PENTWATER HARBOR, MICHIGAN

NORTH PIER AND REVETMENT REPAIR OF

~~EXISTING~~ SECTIONS A, B, C, D, E, F & F-1
PRE-CONS

SOLICITATION NUMBER: DACW35-99-B-0017

STRUCTURE PLAN - INST REQUIRED SECTIONS A, B, D & E

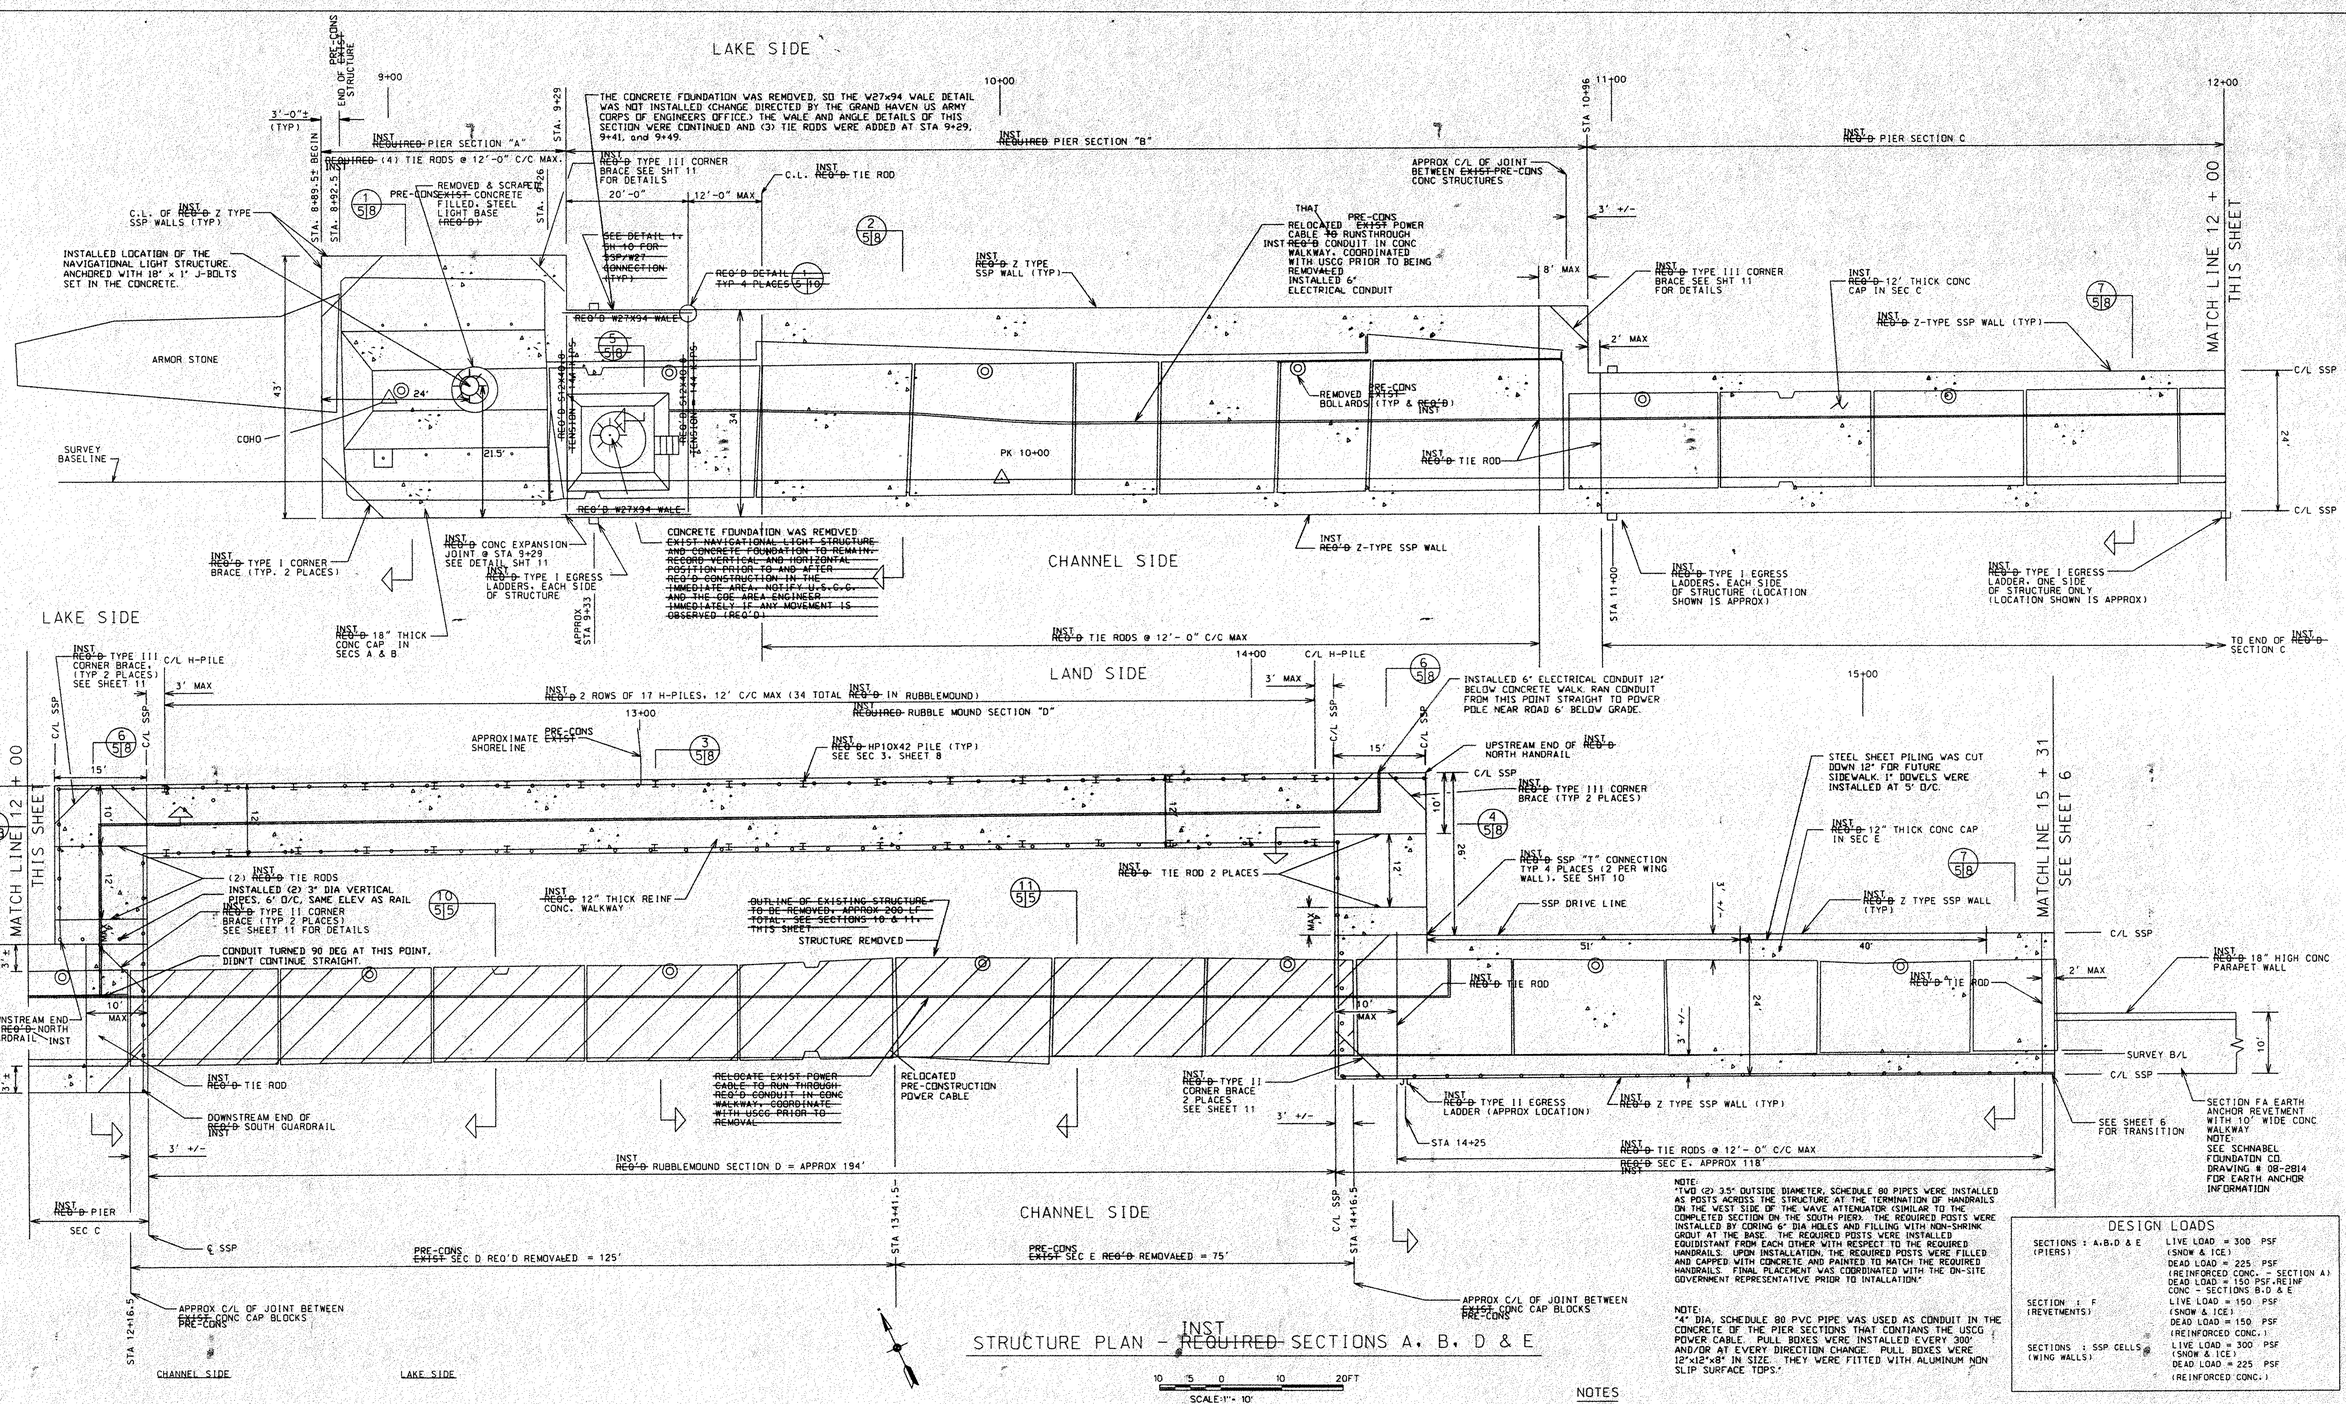
NOTE:
"TWO (2) 3.5" OUTSIDE DIAMETER, SCHEDULE 80 PIPES WERE INSTALLED AS POSTS ACROSS THE STRUCTURE AT THE TERMINATION OF HANDRAILS ON THE WEST SIDE OF THE WAVE ATTENUATOR (SIMILAR TO THE COMPLETED SECTION ON THE SOUTH PIER). THE REQUIRED POSTS WERE INSTALLED BY CORING 6" DIA HOLES AND FILLING WITH NON-SHRINK GROUT AT THE BASE. THE REQUIRED POSTS WERE INSTALLED EQUIDISTANT FROM EACH OTHER WITH RESPECT TO THE REQUIRED HANDRAILS. FINAL PLACEMENT WAS COORDINATED WITH THE ON-SITE GOVERNMENT REPRESENTATIVE PRIOR TO INTALLATION."

NOTE:
"4" DIA. SCHEDULE 80 PVC PIPE WAS USED AS CONDUIT IN THE CONCRETE OF THE PIER SECTIONS THAT CONTIANS THE USCG POWER CABLE. PULL BOXES WERE INSTALLED EVERY 300' AND/OR AT EVERY DIRECTION CHANGE. PULL BOXES WERE 12"x12"x8" IN SIZE. THEY WERE FITTED WITH ALUMINUM NON SLIP SURFACE TOPS."

STRUCTURE PLAN
STA 15+31 TO STA 22+50

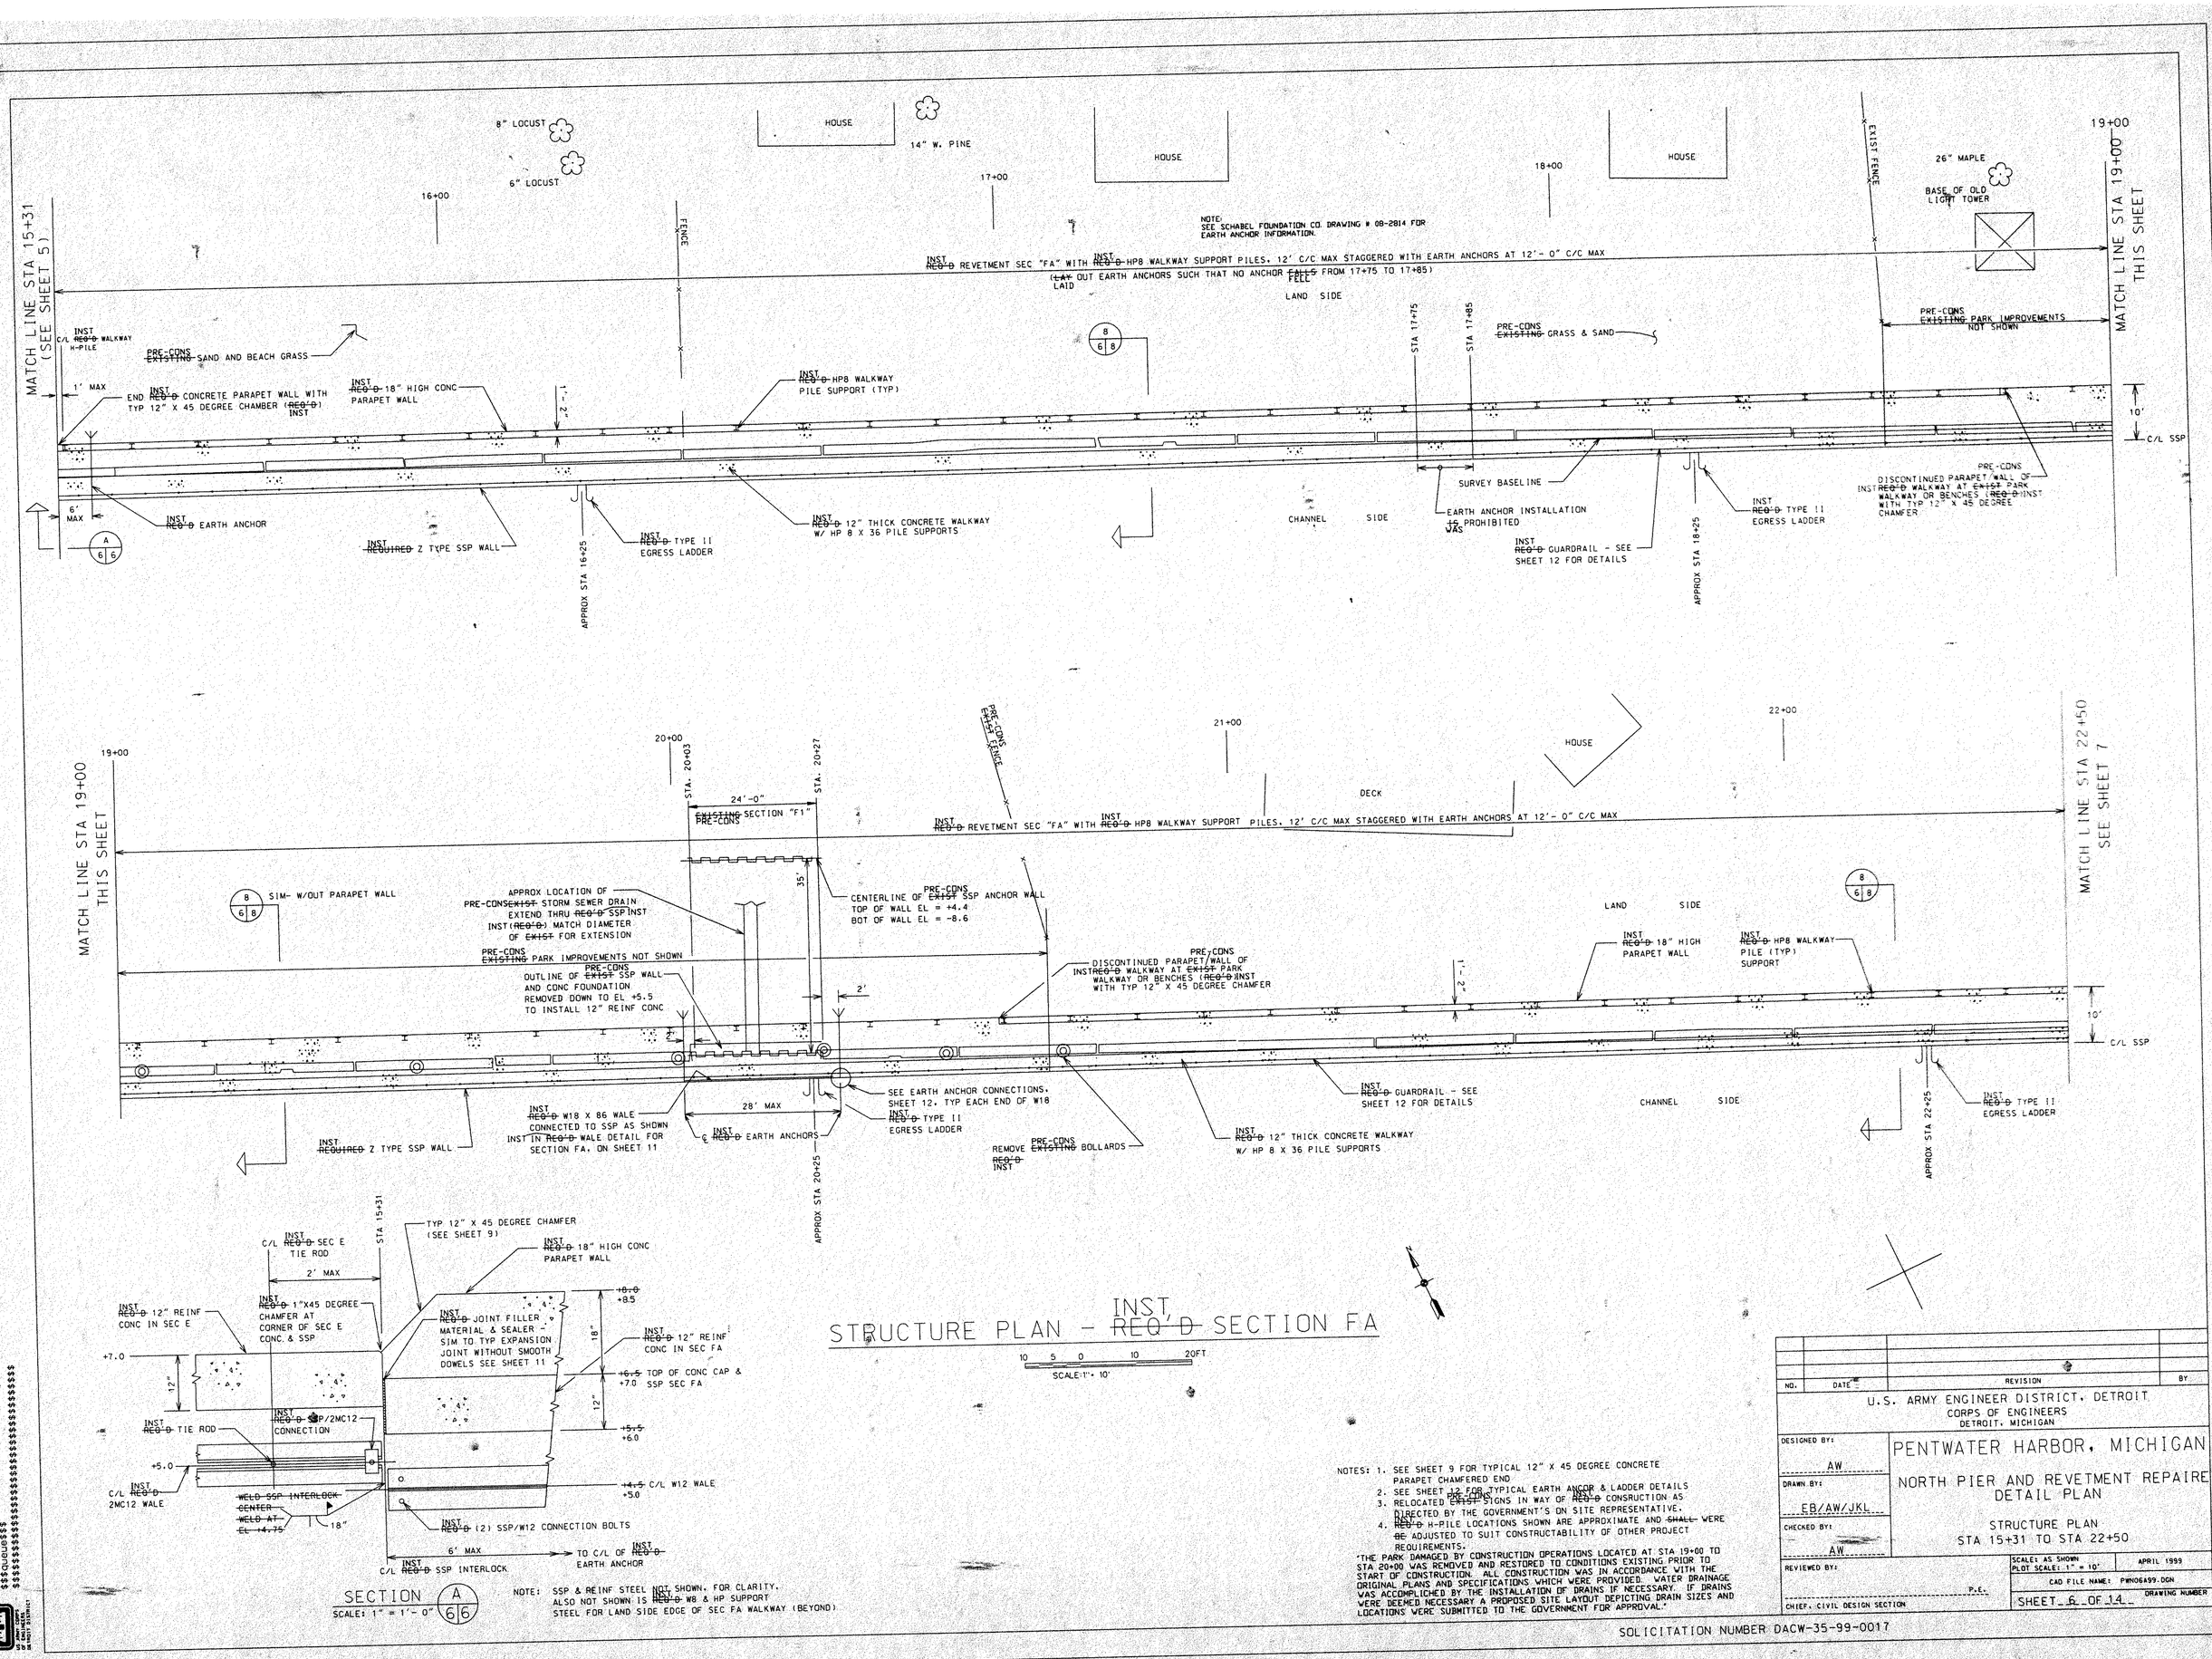
"THE PARK DAMAGED BY CONSTRUCTION OPERATIONS LOCATED AT STA 19+00 TO STA 20+00 WAS REMOVED AND RESTORED TO CONDITIONS EXISTING PRIOR TO START OF CONSTRUCTION. ALL CONSTRUCTION WAS IN ACCORDANCE WITH THE ORIGINAL PLANS AND SPECIFICATIONS WHICH WERE PROVIDED. WATER DRAINAGE WAS ACCOMPLICHED BY THE INSTALLATION OF DRAINS IF NECESSARY. IF DRAINS WERE DEEMED NECESSARY A PROPOSED SITE LAYOUT DEPICTING DRAIN SIZES AND LOCATIONS WERE SUBMITTED TO THE GOVERNMENT FOR APPROVAL."

REPAIR SECTIONS

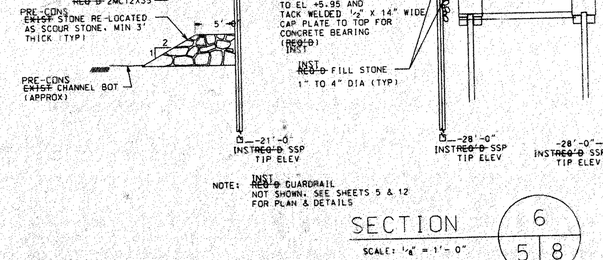
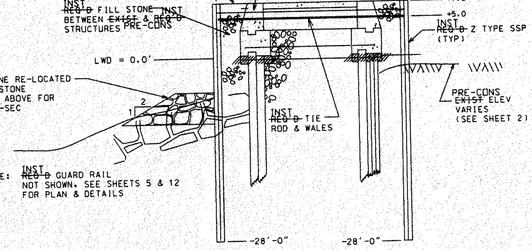
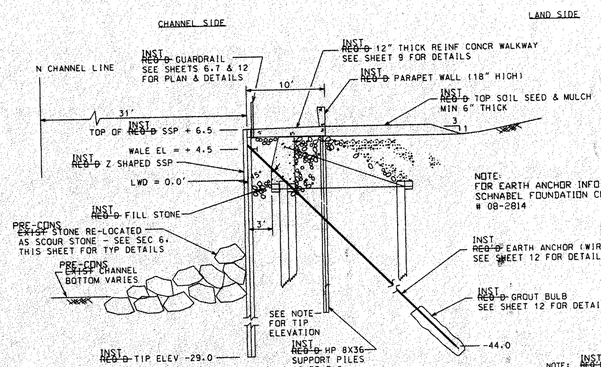
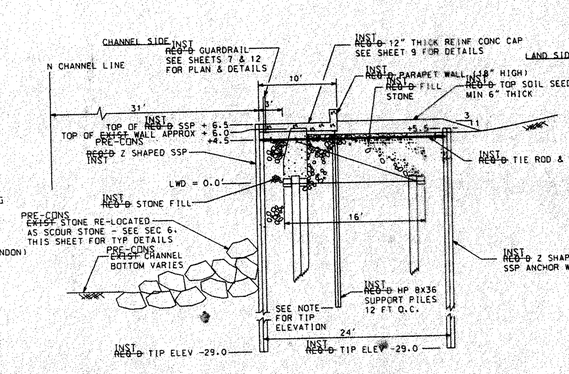
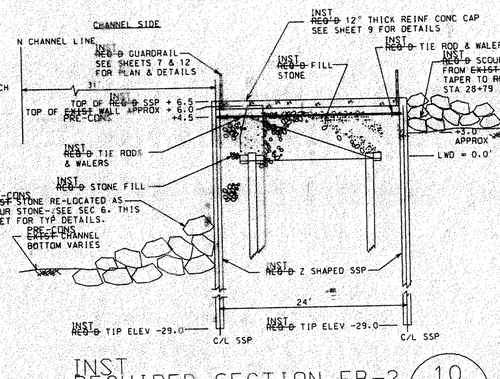
"THE TOP OF THE REQUIRED STEEL SHEET PILINGS ON THE CROSS SECTIONS 8, 9 AND 10 LOCATED ON THE ABOVE REFERENCED DRAWING WERE REVISED FROM AN ELEVATION OF +6.5' TO +7.0' ABOVE LWD."

TYPICAL CONCRETE EXPANSION JOINT DETAIL

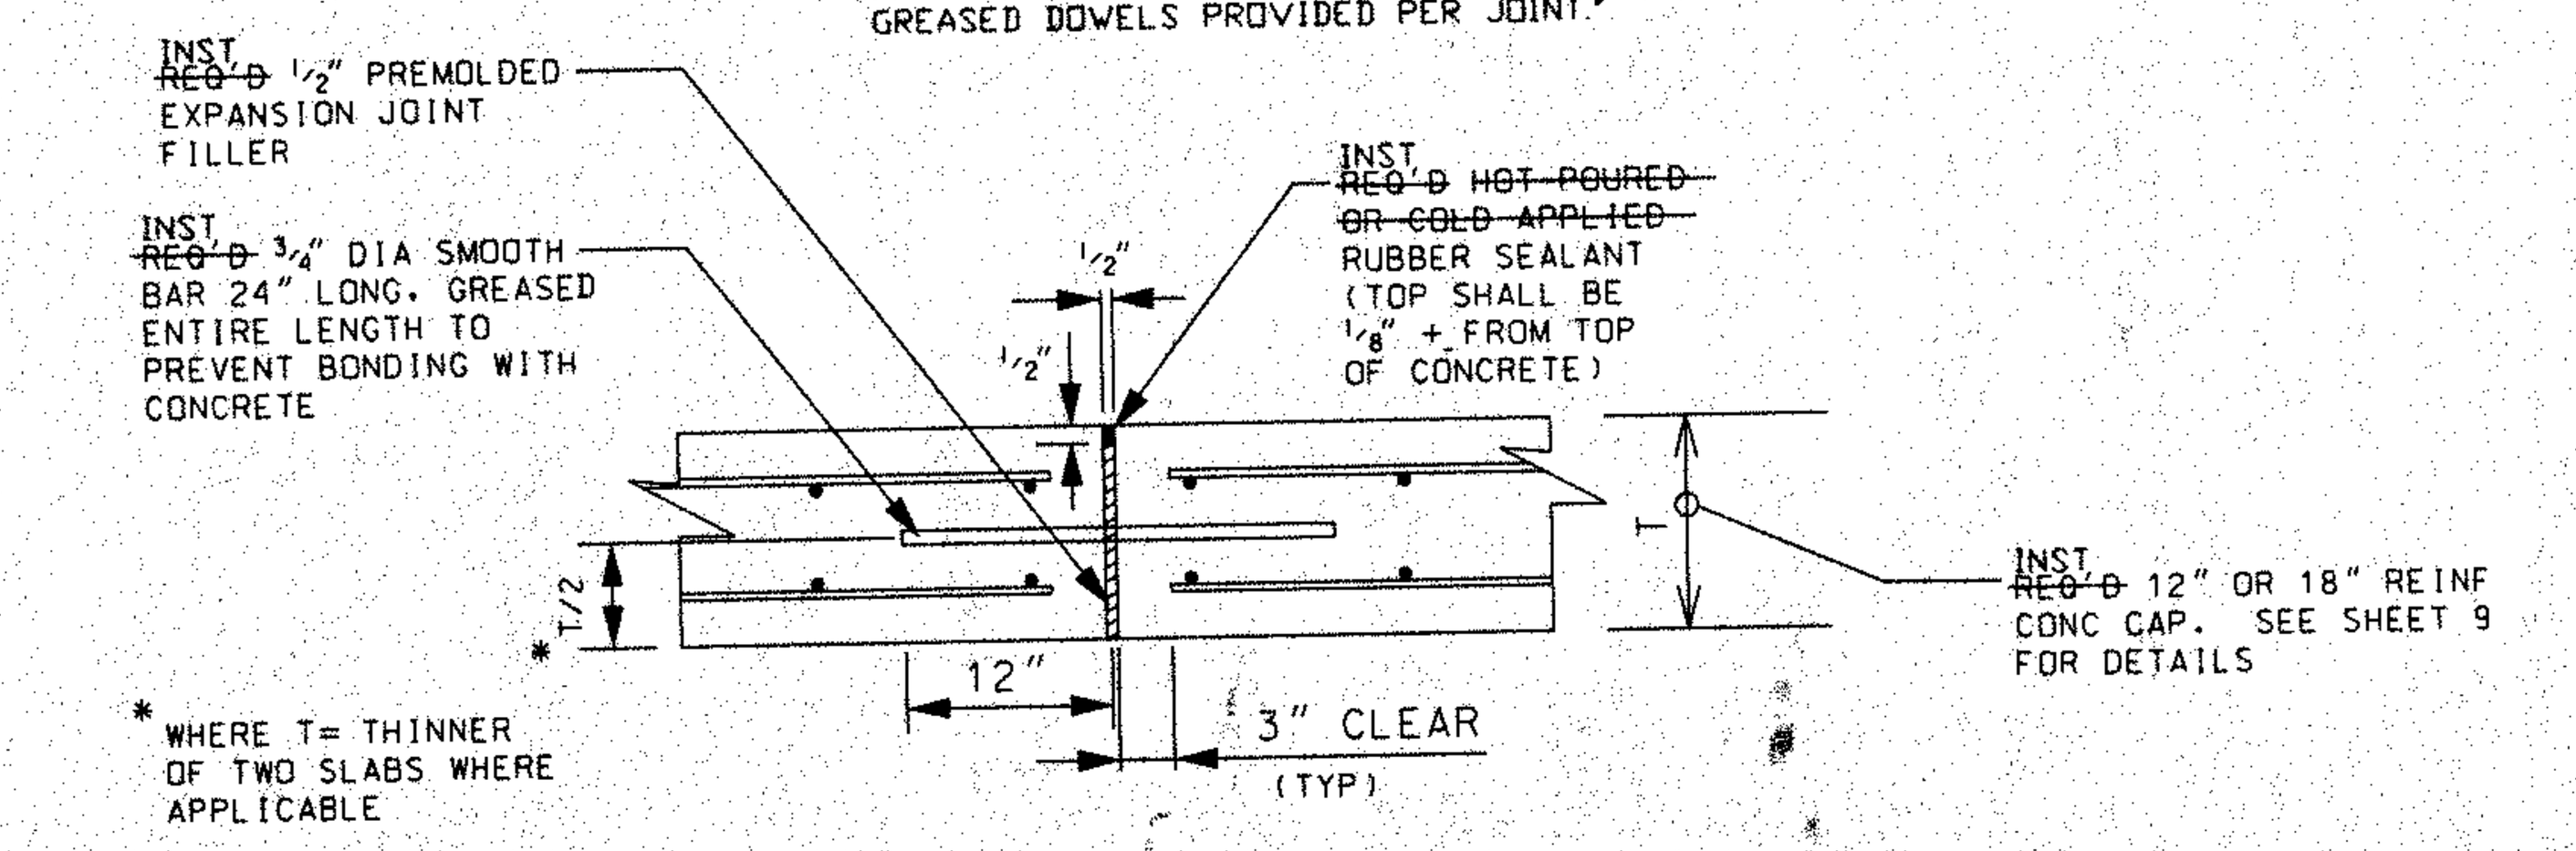
NOTE:
"EXPANSION JOINTS WERE CONTINUOUS ACROSS PARAPET WALL, WITH TWO ADDITIONAL 3/4" GREASED DOWELS PROVIDED PER JOINT."
